Site Instruction

SI 30

PROJECT : Hampton Manor
PROJECT No : 1136.13
DATE : November 27, 2018

Title: Revised Door Schedule

STOUFFVILLE	ROYAL PINES HOMES	ONTARIO
Project Architect:	B.GRAZIANI	
Assistant Designer:	R.LINCOLN	
Drawn By:	S.G.	
Checked By:	G.COLANGELO/D.BIASE	
Plot Date:	JUL 4, 2018	
Job #	1136.13	
PARKING PLAN

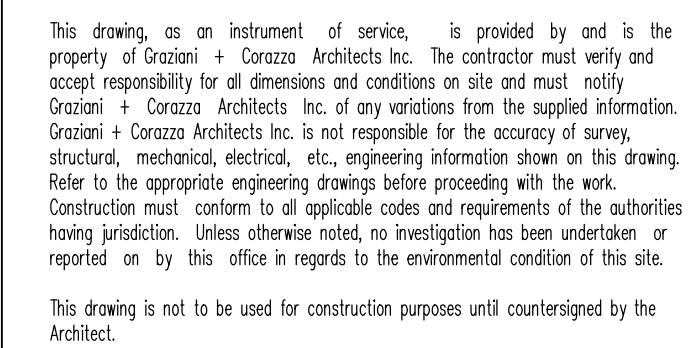
A231 – Underground Parking

- Revised "T01b" door for stair D.

1:50 A302a

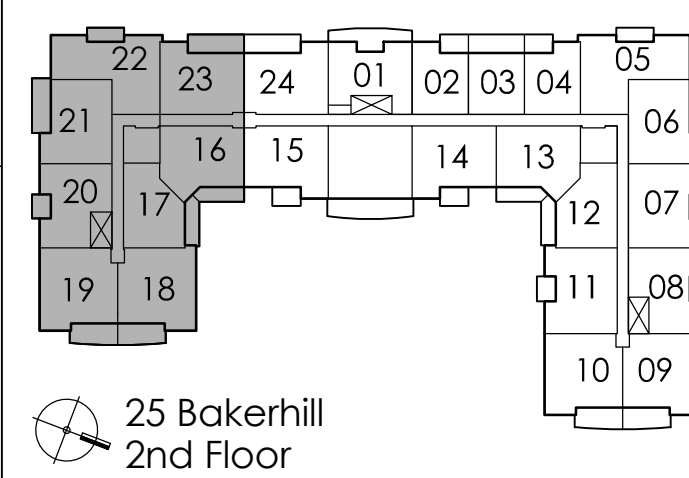
A302a, A302c – 2nd Floor Partial Plans (Enlarged)

- New door on Stair A & B landing.

A302a, A302c – 2nd Floor Partial Plans (Enlarged)

- Revised door "D04" at firewall

1:100 A307

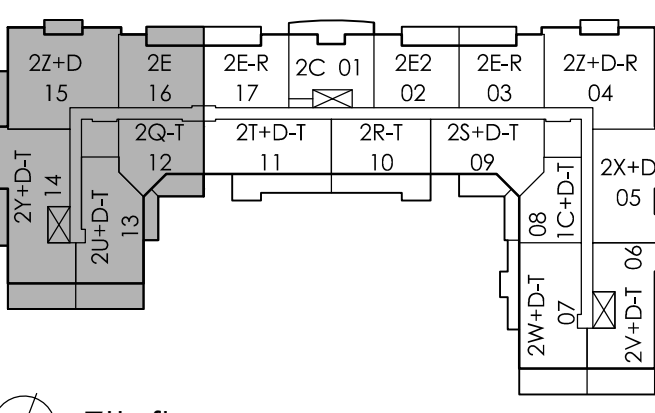
A307 – 7th Floor Plan (Overall)

- Revised door "D04" at firewall.

1:50 A701

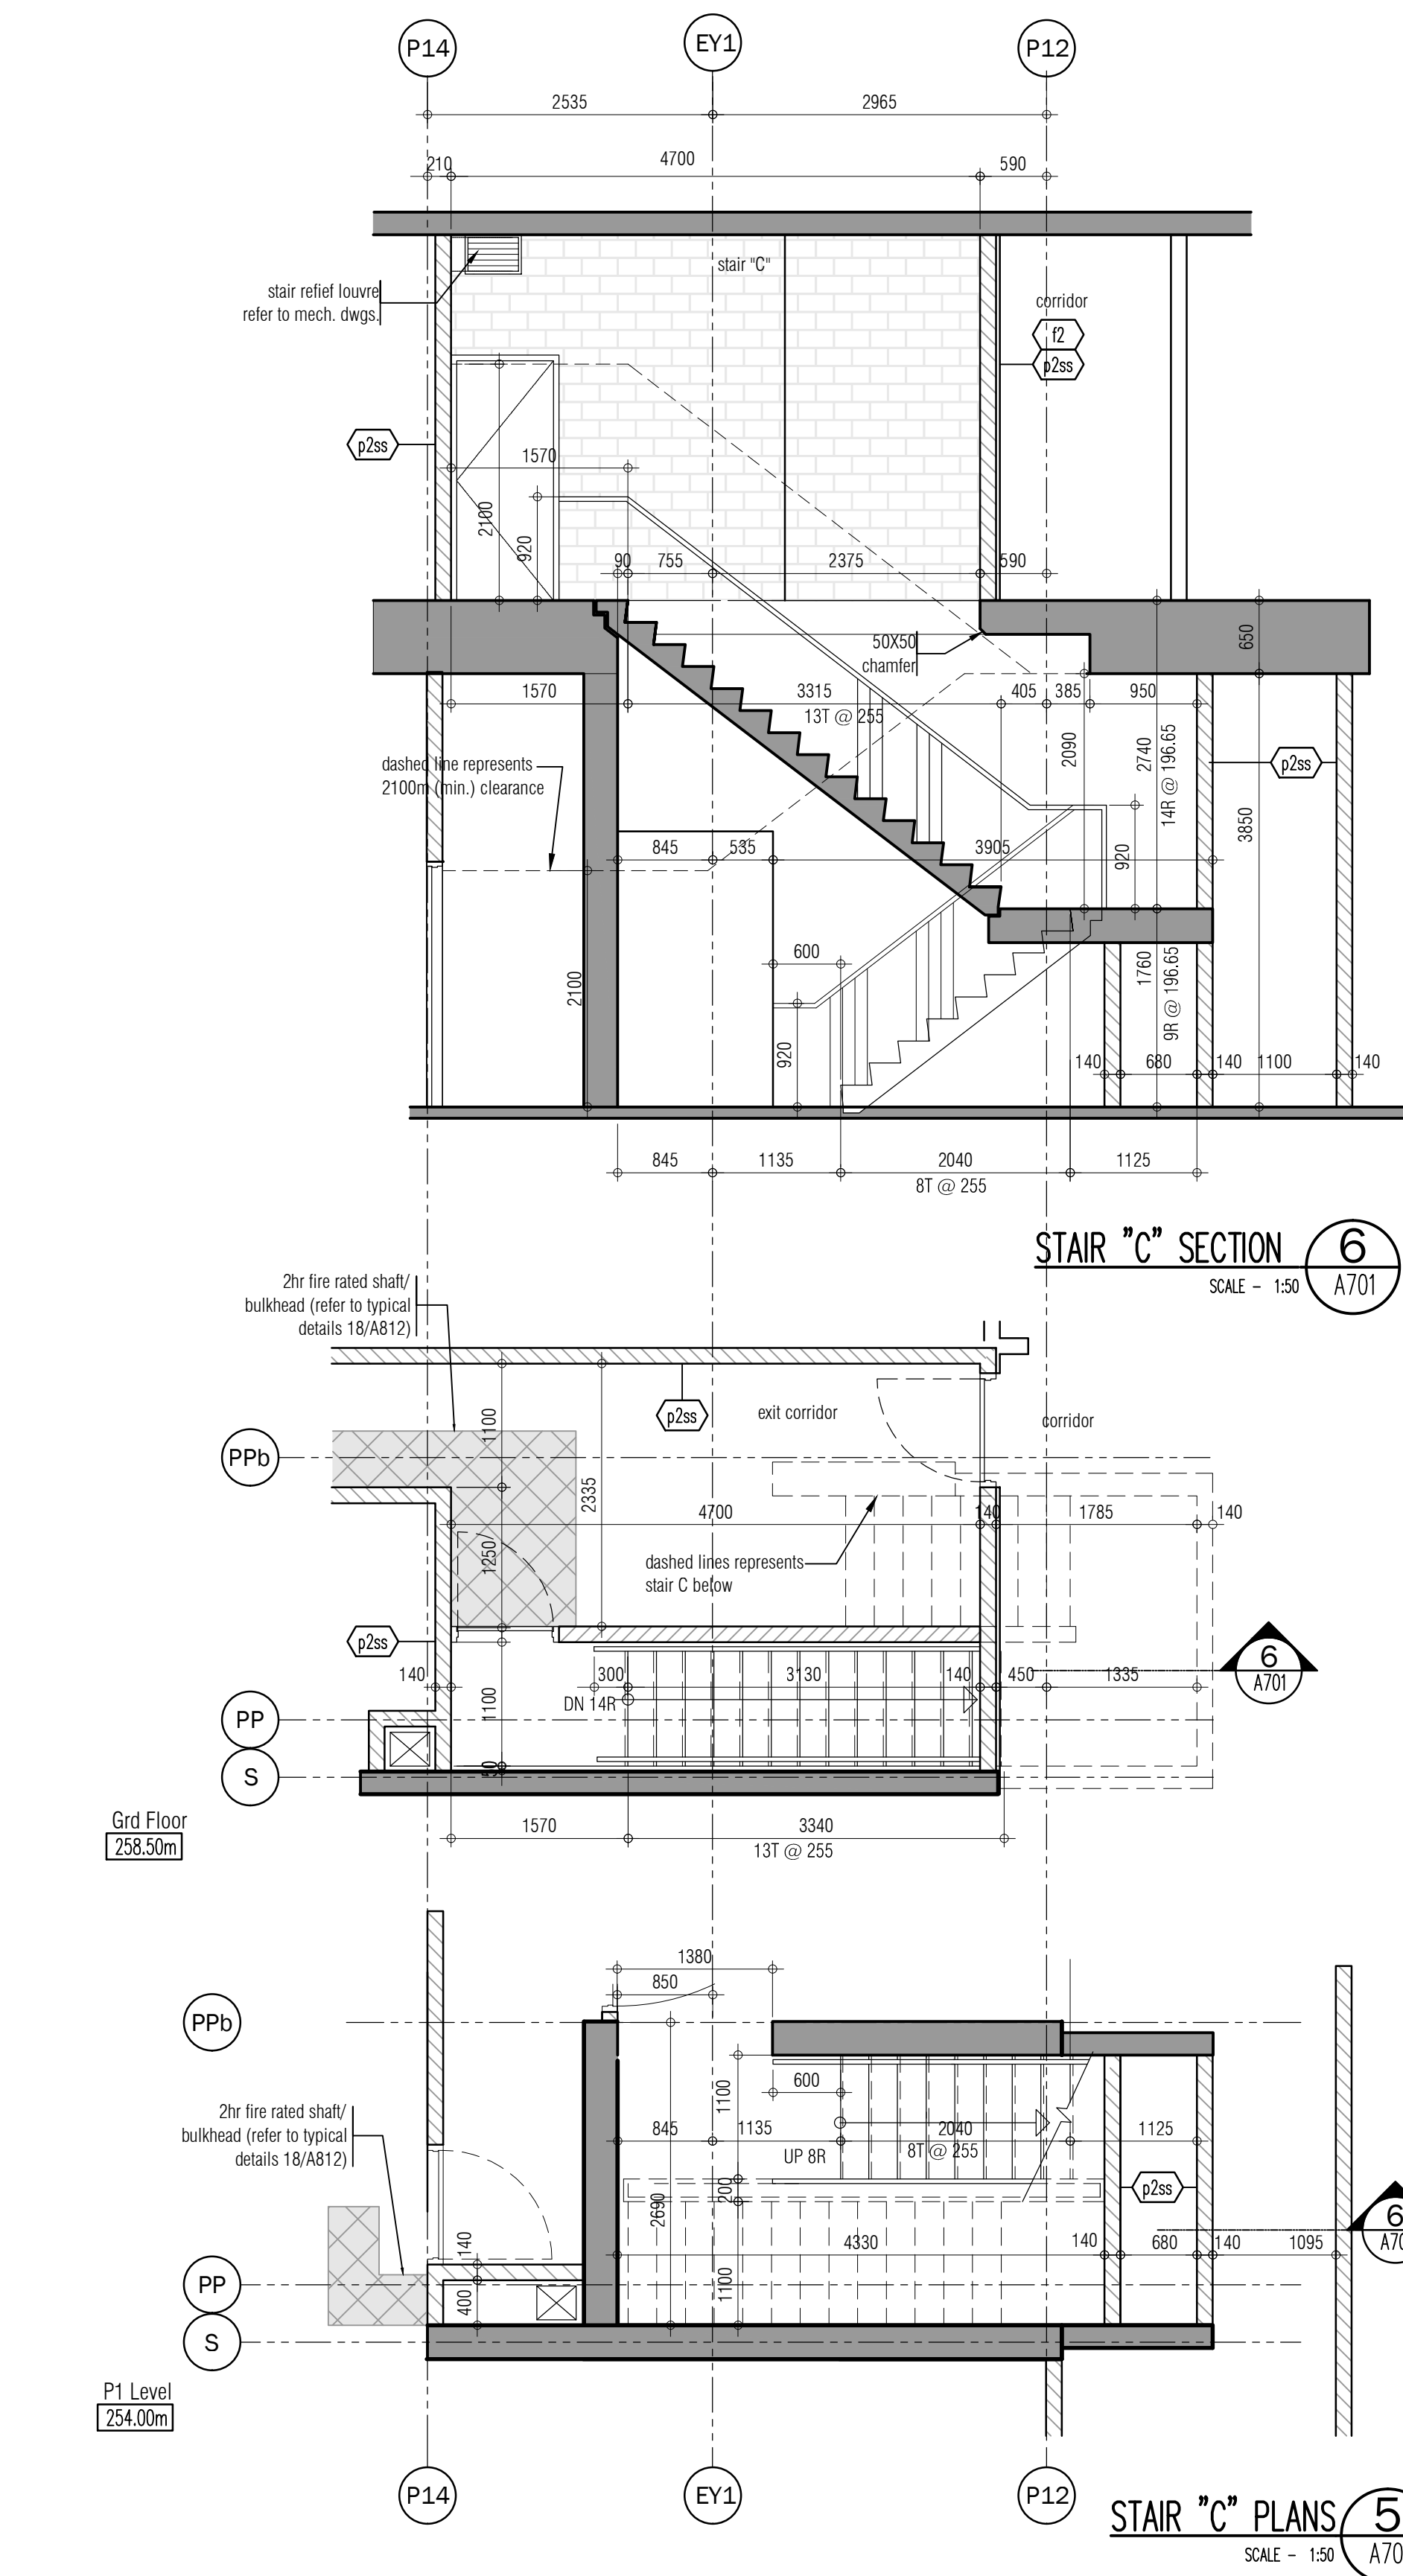
A701 – Stair Drawings

- New door on 2nd floor stair A & B landing.
